SuperSport “STD” Heat Guard Installation Sachs Shock Inspection

Models: M.Y. 2017 and 2018 SuperSport STD version
Service Bulletin SRV-TSB-17-007

Date: Wednesday, September 6th, 2017
To: Dealer Principal, General Manager, Service Manager, North American Dealer Network
From: Richard Kenton, Technical Director; Jonathan LaForte, Technical Manager

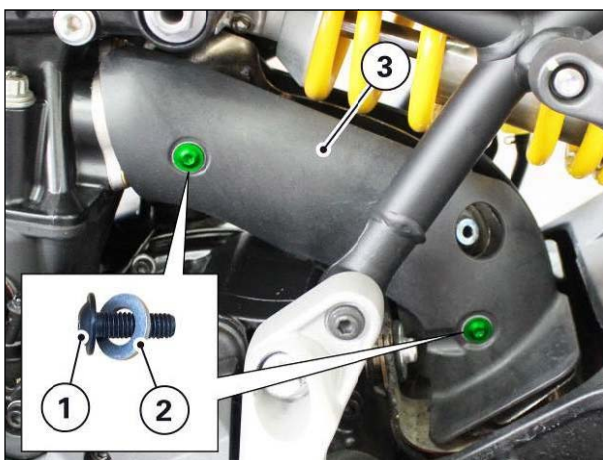
Ducati has received feedback regarding possible cosmetic damage to the Sachs rear shock absorber bottoming-stop cushion installed on STD versions of the SuperSport model. To prevent this damage, an additional central heat guard has been designed for installation on the vertical exhaust manifold. The new part no. is 4601G411A.

During installation of the central heat guard, it will be necessary to visually inspect the condition of the Sachs rear shock absorber bottoming-stop cushion. If evidence of cosmetic damage and deformation to the Sachs rear shock absorber bottoming-stop cushion is present, the rear shock absorber Part no.36521542A can be replaced. If this is the case, a clear picture of the damage must be attached to the warranty claim.

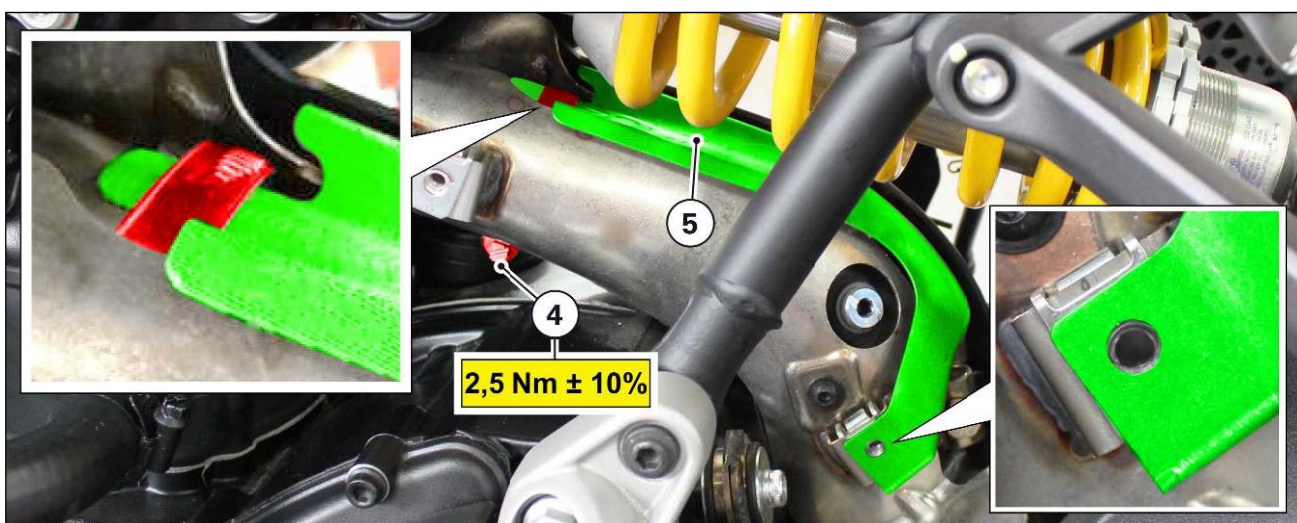
- 1) Working on the LH side of the motorcycle, remove the **2 M6x18 screws (1)** with the relevant **washers (2)** and slide the **left heat guard cover (3)** out towards the front side of the vehicle.
- 2) Loosen the **clamp (4)** securing the RH and LH heat guards.

- 3) Install the **central heat guard (5) Part no.4601G411A** as shown in the figure by inserting the tab under the **clamp (4)** securing RH and LH heat guards.

Check that the hole of the central heat guard (5) is aligned with the fixing hole of the left heat guard cover (3).

- 4) Tighten the clamp (4) to a torque of $2.5 \text{ Nm} \pm 10\%$.

- 5) Install the **left heat guard cover (3)** and tighten the **2 M6x18 screws (1)** with the relevant **washers (2)** to a torque of $8 \text{ Nm} \pm 10\%$.
